County of Fairfax, Virginia

January 10, 2013

STAFF REPORT ADDENDUM

APPLICATION RZ/FDP 2012-BR-003

EXISTING CONDITIONS PLAN
TARIQ KHAN PROPERTY

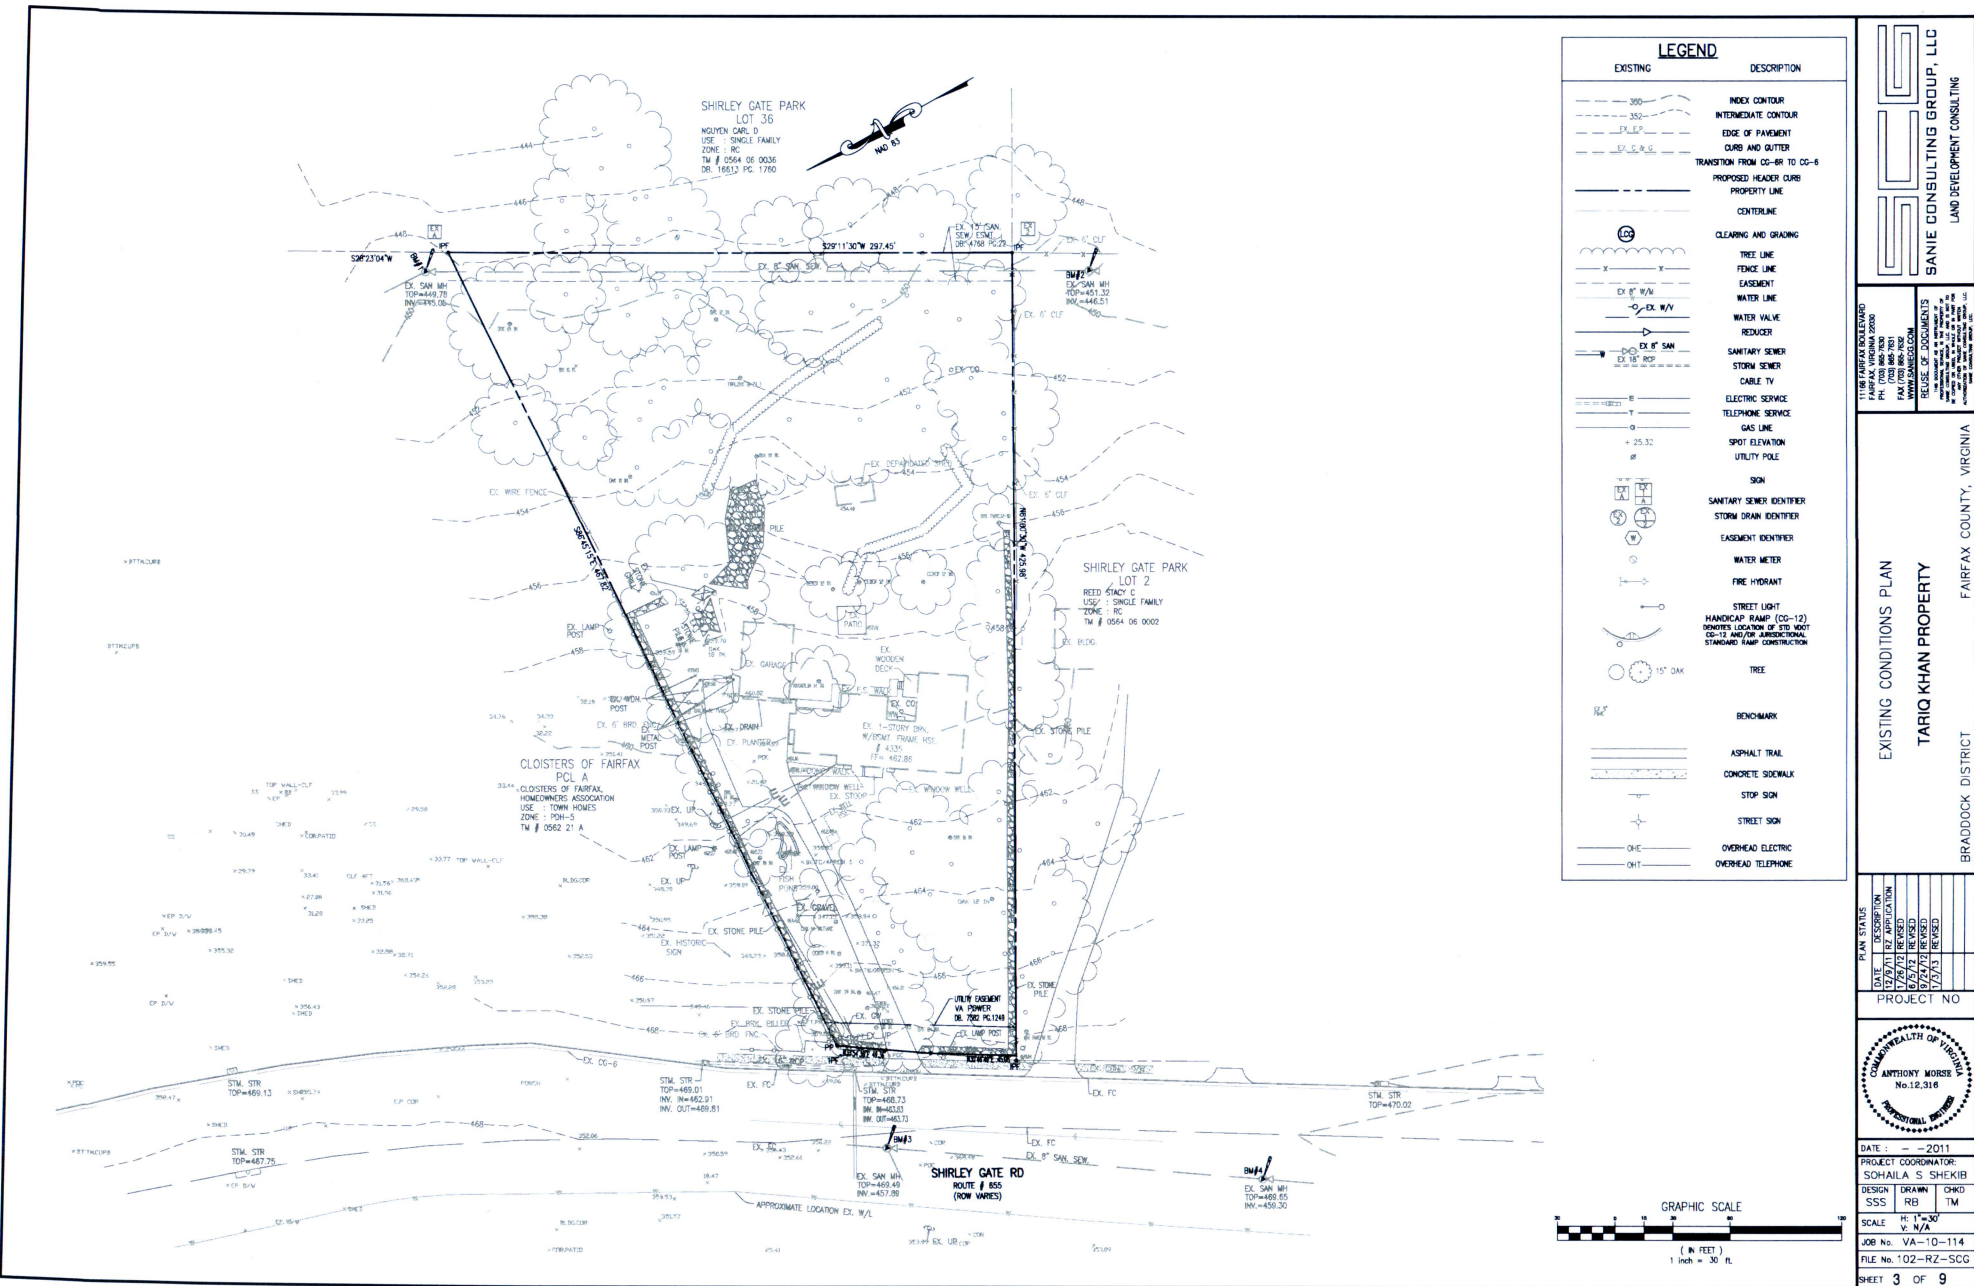
Revised Final Development Plan – January 3, 2013 (Attachment 1)*Revised Site Layout*

The applicant's revised CDP/FDP now shows two lots to be accessed via a 20' wide private street and shared driveway from Shirley Gate Road. The lots, measuring 17,043 sf. and 17,992 sf., allow the homes to face Shirley Gate Road at a slight offset, set back about 200 feet from the right-of-way (consistent with the properties to the south). The remainder of land at the eastern end of the property and at the southwest corner is set aside as a conservation area (totaling 28,817 sf.) that would be maintained in a natural state by the proposed homeowners association. The revised typical house layout on Sheet 4 of the CDP/FDP shows larger homes than the previous submission (about 4,000-5,000 sf. in area), with minimum setbacks of 49 feet, 28 feet, and 8 feet for the front, rear and side yards, respectively. The architectural design depicted on Sheet 6 continues to reflect a colonial theme, similar to that found in the adjacent Cloisters neighborhood.

The revised site layout has addressed staff's previous concerns about integration with the surrounding community, as the orientation of the homes has been shifted so that both will face directly onto Shirley Gate Road. In addition, the homes are now set back further on the lot and are roughly aligned with existing single family homes along Shirley Gate Road to the south.
